Platform A1 - Booth area
Previous comments are
still valid, see following
slides

Platform A1 - Booth area

Important: the 12 columns of the Spray Booth have been modified after change of the Scrubber technology by Renault-VAZ

Axes 5/023

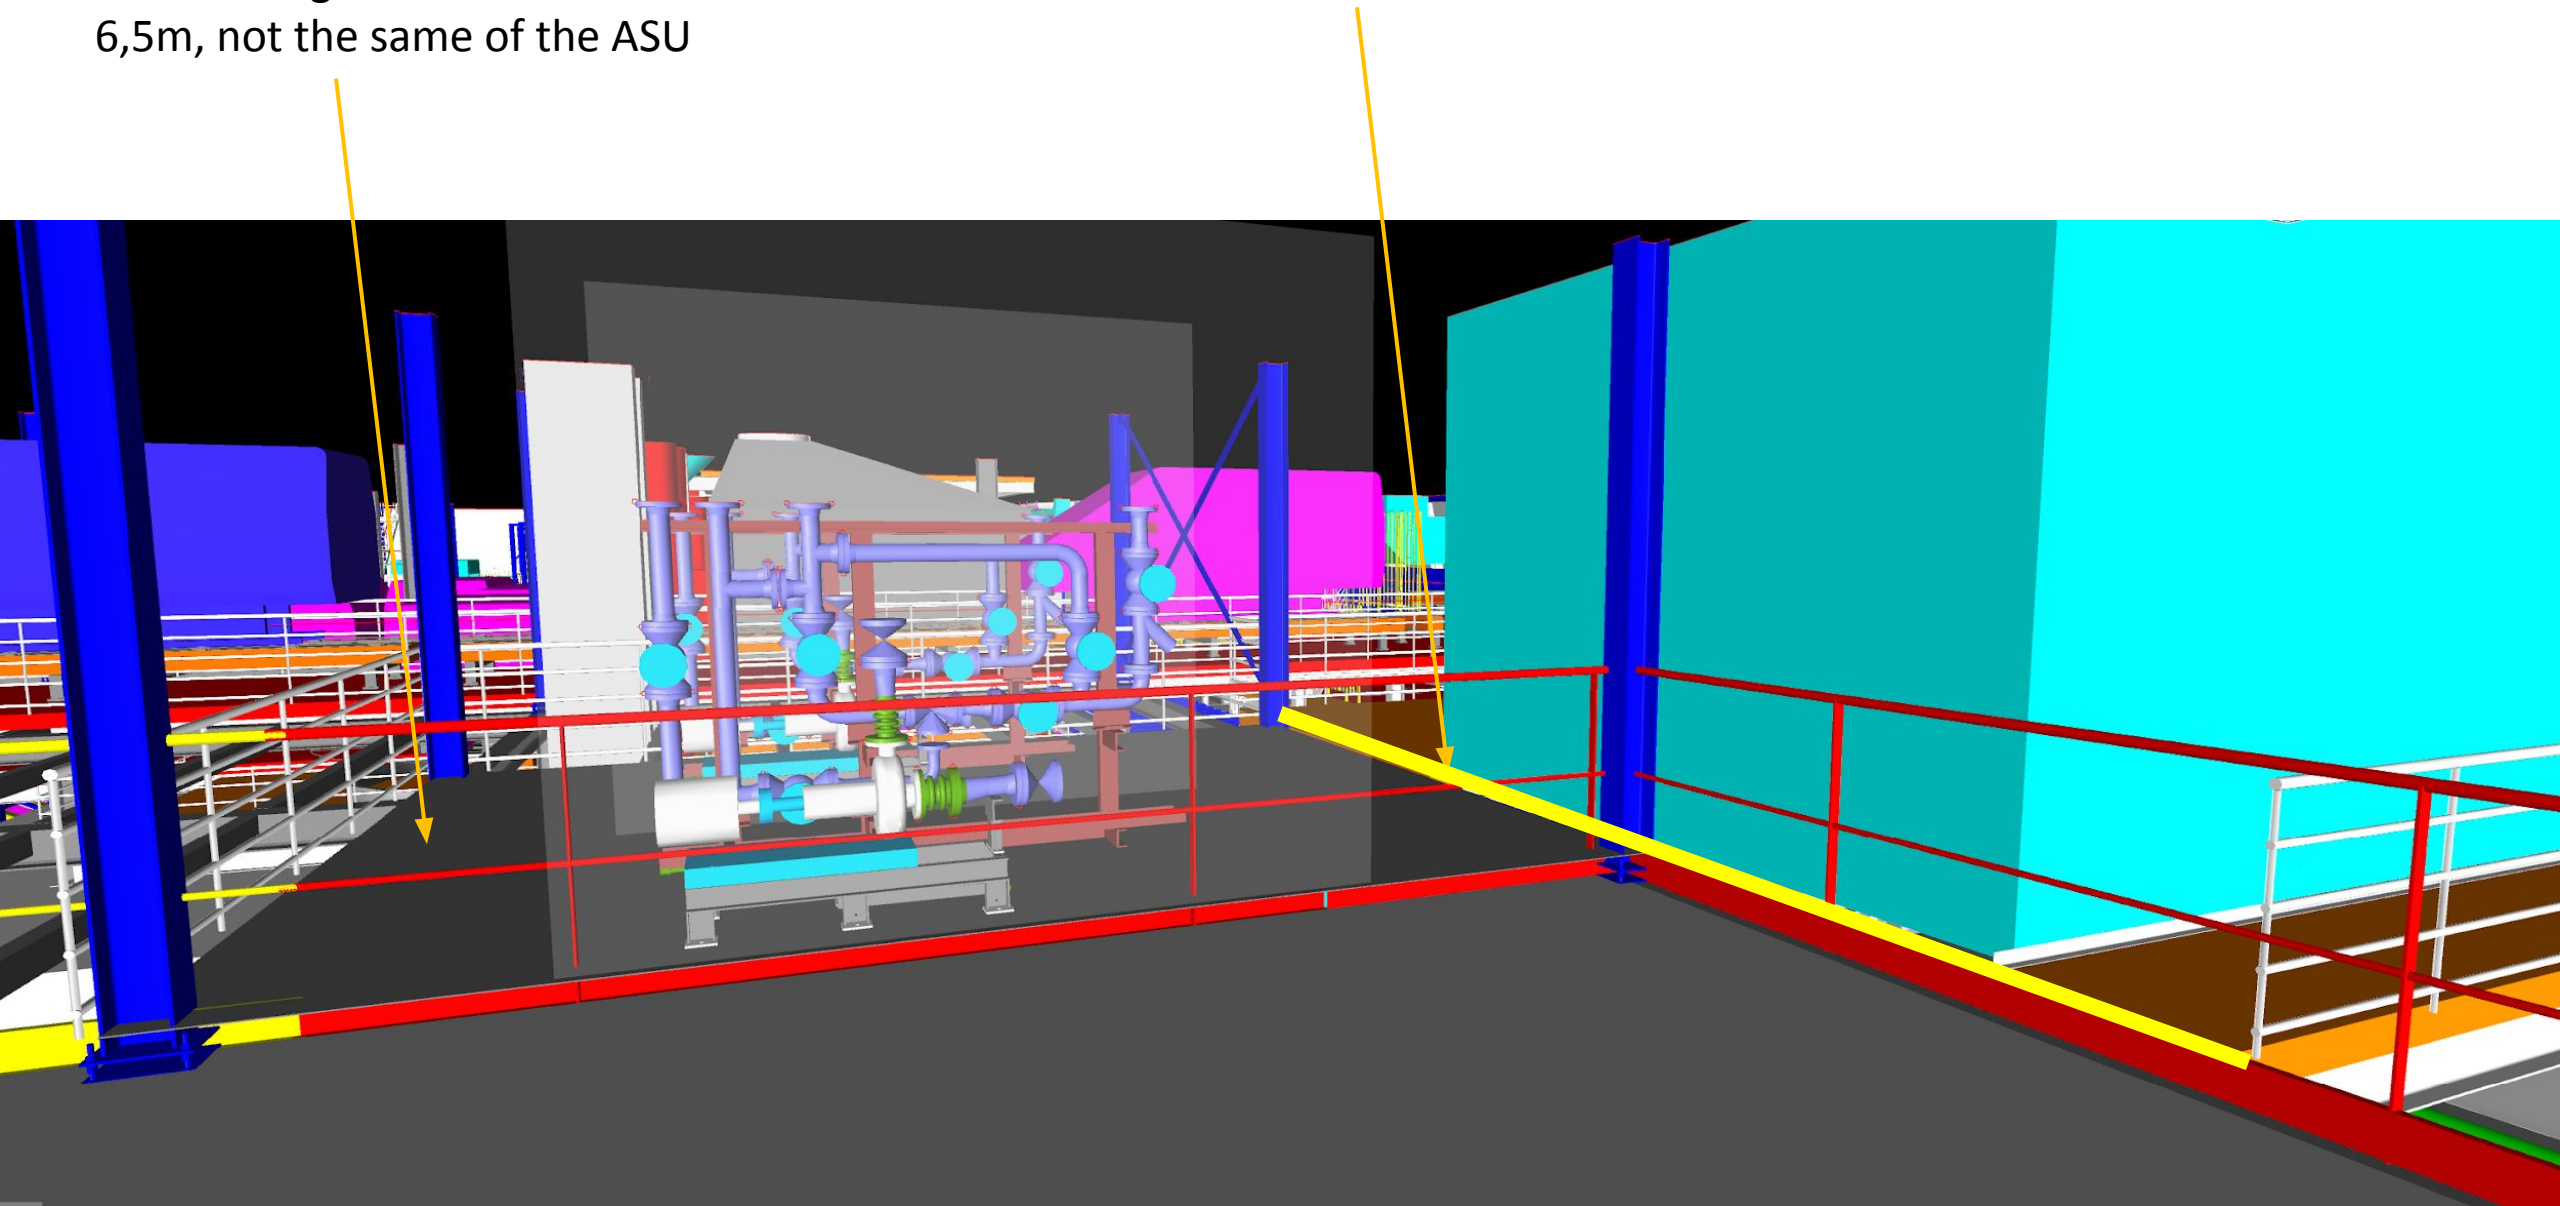
Move monorail columns 350mm left
according to last gen. Layout (04/05)
Otherwise ASU doors won't open
correctly

This walking level should be at elev.
6,5m, not the same of the ASU

We will have a step along this line

Axes 10/022

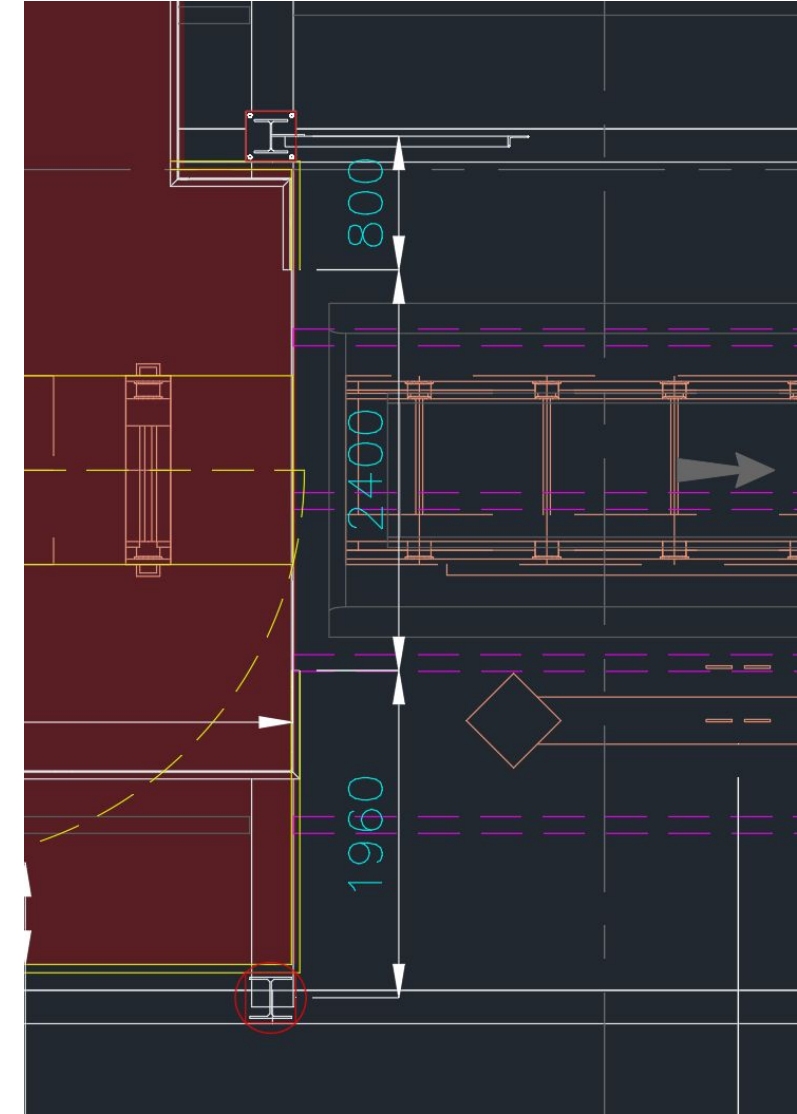
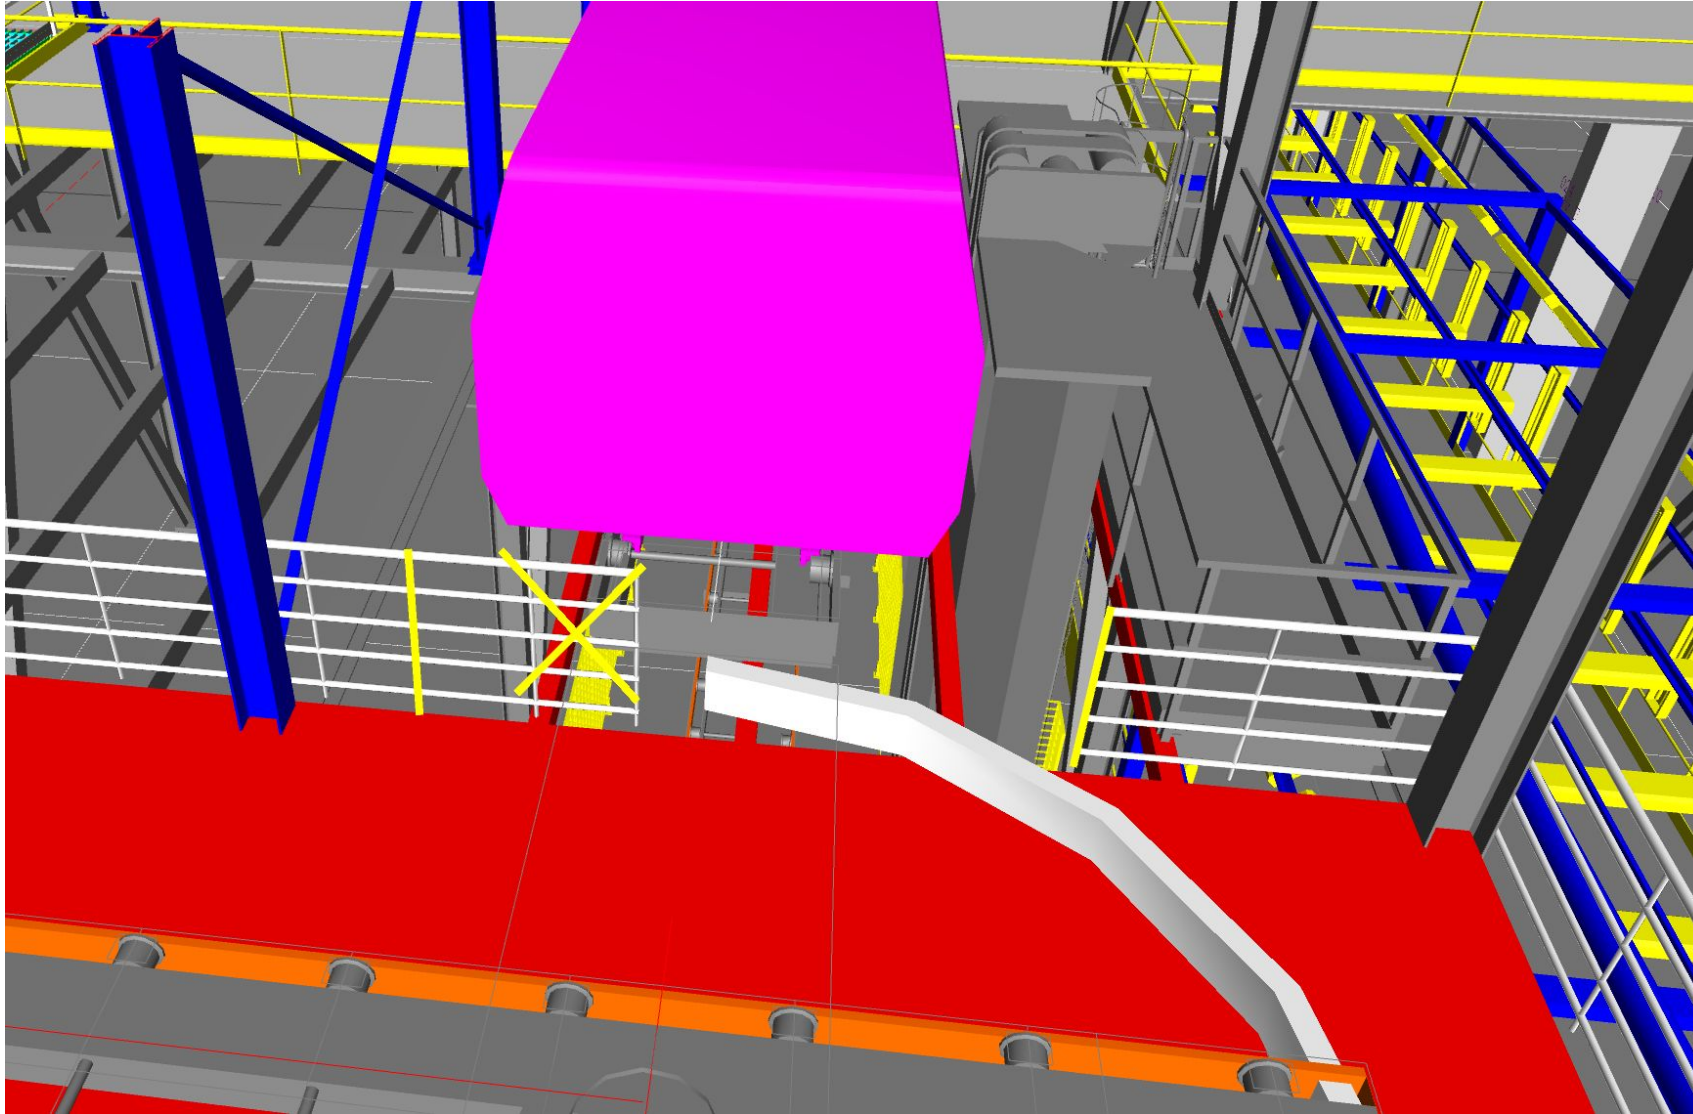
Platform B – (022/10-11): adjust handrail
according to Layout dimensions (right picture)

Axes 5/017

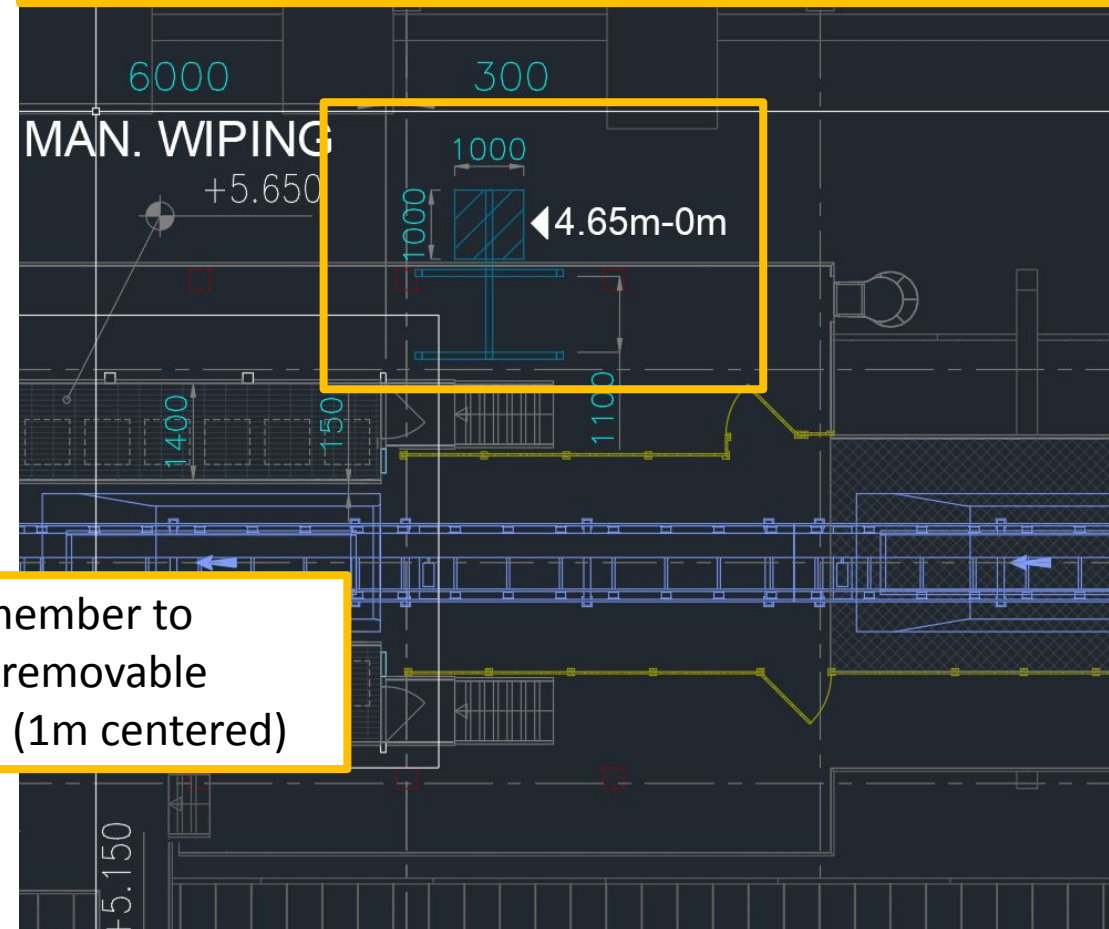
Move monorail from
0,00 to 4,65 (platf.
A1)

Looks like you used same monorail of ASU, this should
be smaller, it downloads only the empty filters of the
Drypan

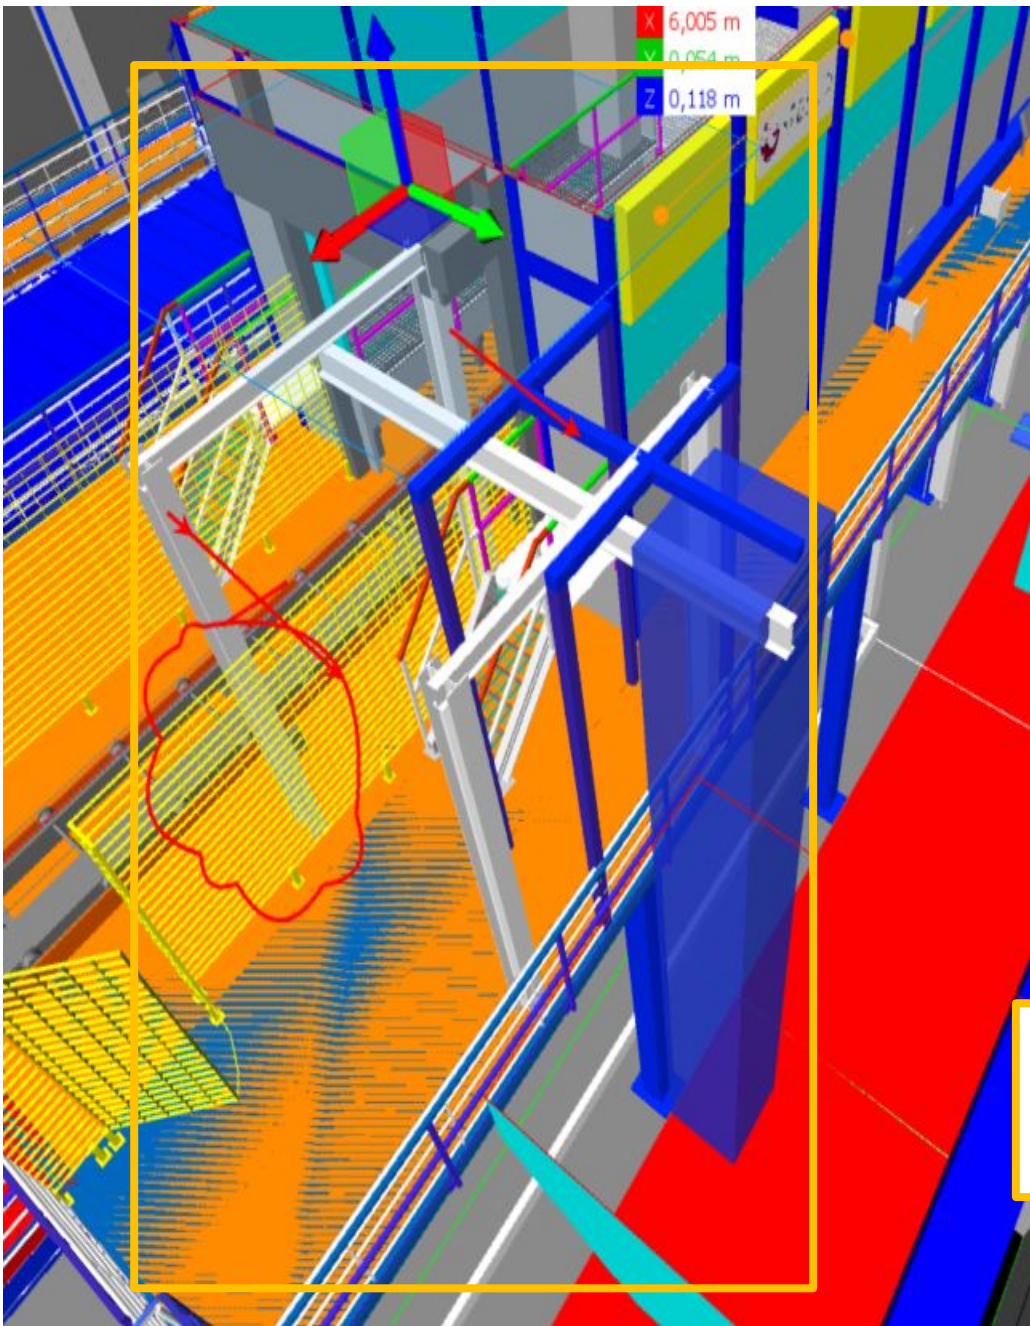
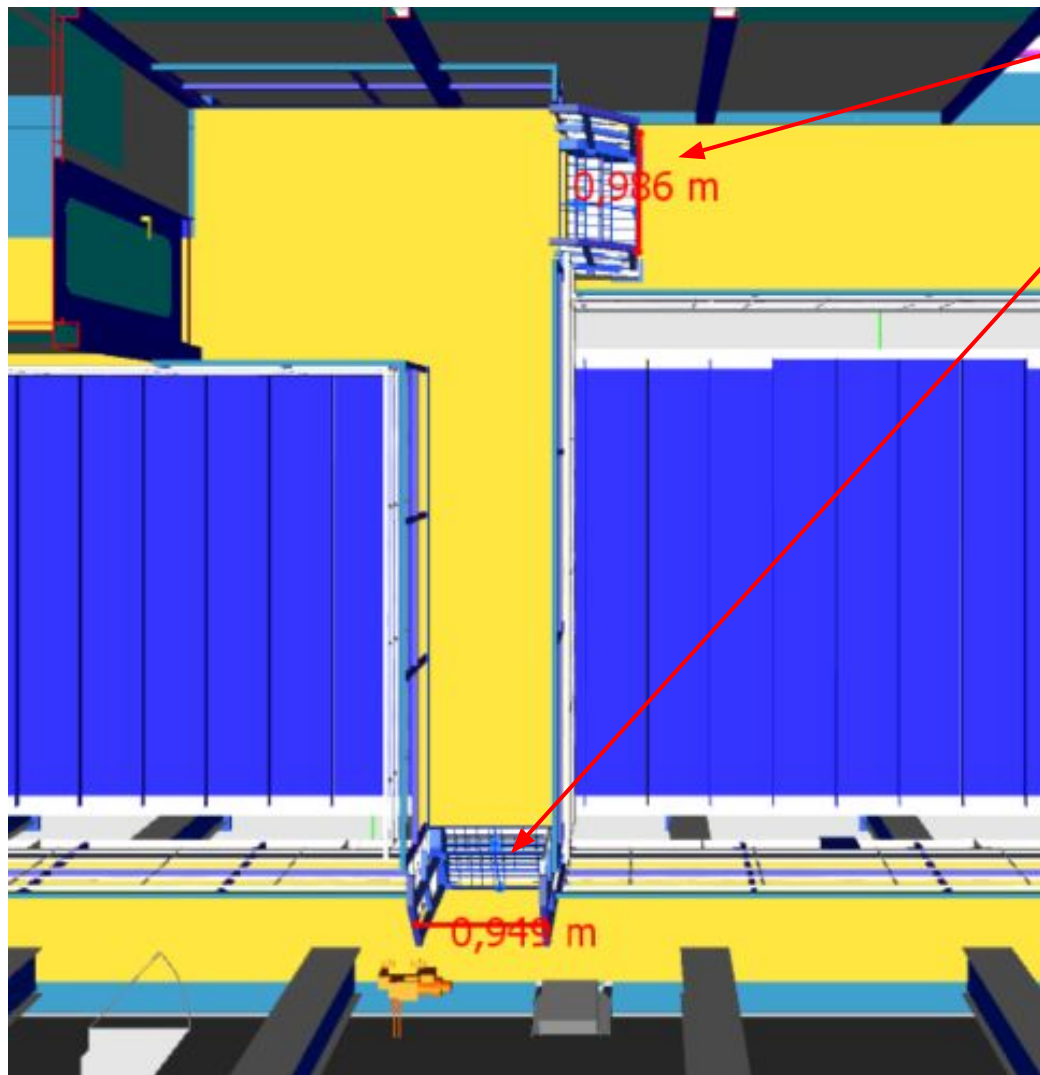
Also remember to
provide removable
handrail (1m centered)

Stairs to be minimum 1 meter
for safety evacuation
(net dimension between
handrails)
